OVERLAND FLOW REPORT STAGE 1

PROPOSED DEVELOPMENT: MAMRE WEST PRECINCT ORCHARD HILLS NSW

Rev: B

8. PEER REVIEW

Figure 5.2 South Creek and Cosgrave Creek 1% AEP Hydrographs

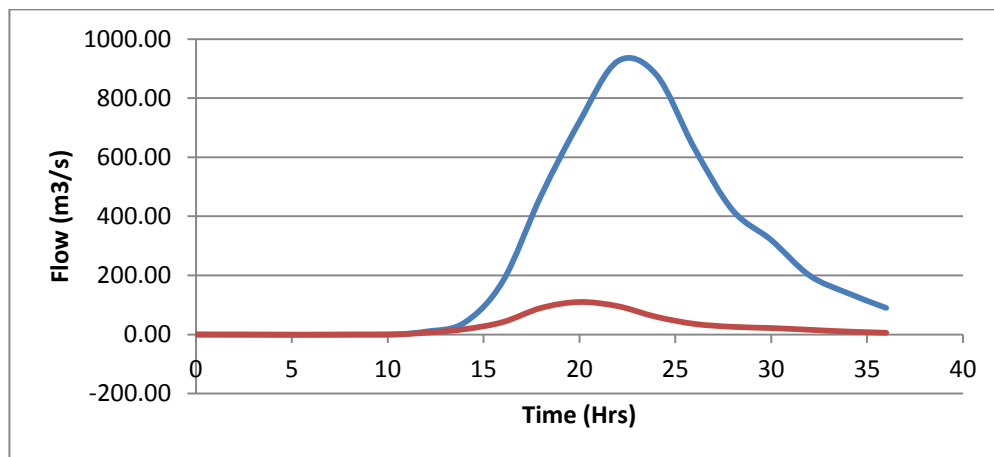
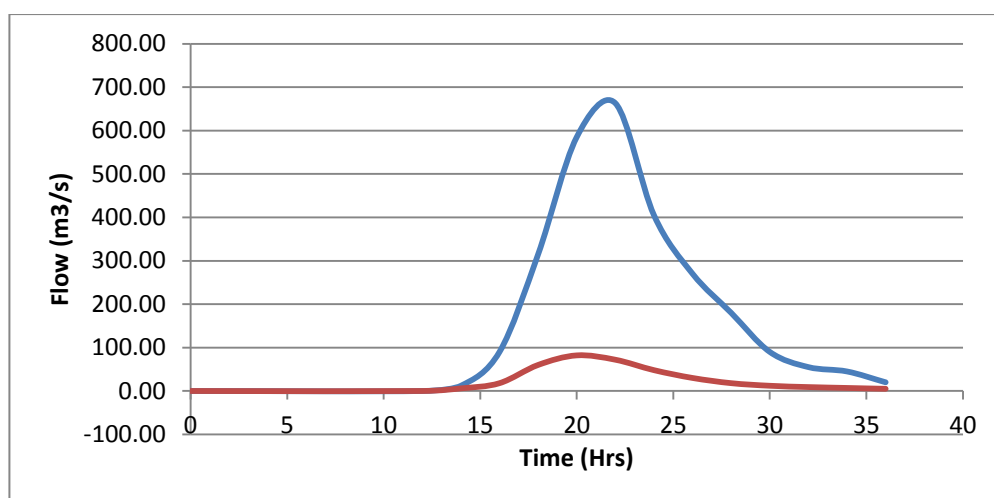
Item B1.d) Hydrology should be based on the flows from the RMA-2 model. The basic two-node RAFTS model is not considered satisfactory for the definition of flows and has been shown to predict lower flows for most design events (refer Table 2).

Inflow hydrographs have been adjusted to match those recommended in Table 2 of Worley Parsons Peer Review Report. Refer to **Section 5.2** and **Appendix C** of the report.

Figure 6.1. Model Extent and Model Boundary Locations

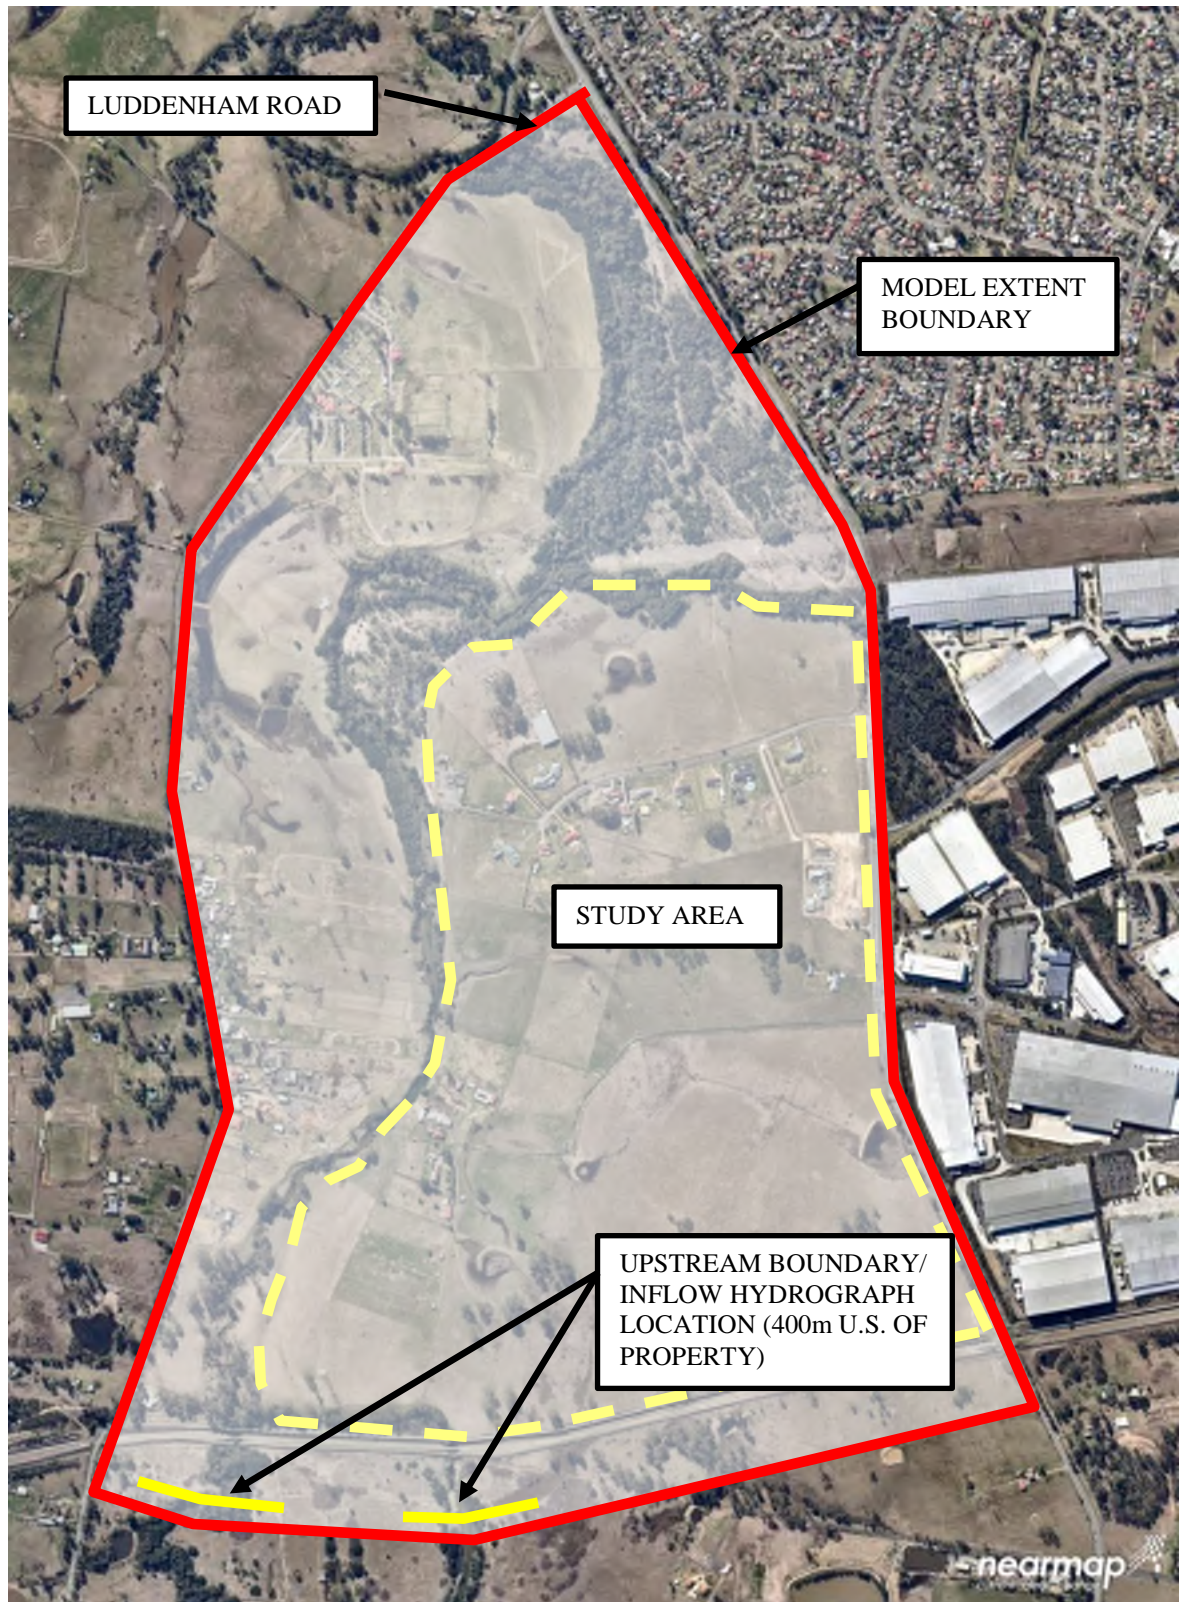
Item B1.a) The downstream boundary levels are inappropriate and require review and update. It is recommended that peak flood levels from the RMA-2 flood model be adopted to ensure consistency. These peak flood levels are provided within Table 1.

Item B1.b) The upstream boundary should be located a sufficient distance upstream to cover the extent of predicted impacts from the proposed development. It is unclear if sensitivity analysis has been undertaken to ensure the current set-up is satisfactory.

Item B1.c) The model extents should extend to cover the PMF flood extent.

Modeling has been updated to include the recommended downstream flow boundaries. Confirmation of the downstream boundary levels used has been included in **Section 6.2** of the report.

A sensitivity analysis has been undertaken which confirms the upstream boundary, located 400m from the property boundary, is sufficiently located far enough from the property to enable appropriate scenario testing relating to the proposed development.

Please refer to **Section 6.2** and **Appendix E** of the report.

The completed model extent sufficiently covers the PMF event. The modeling comparison shows good agreement of flood surface levels with the RMA-2 modeling. The PMF model extents allow for a suitable level of information to enable emergency response planning for the development.
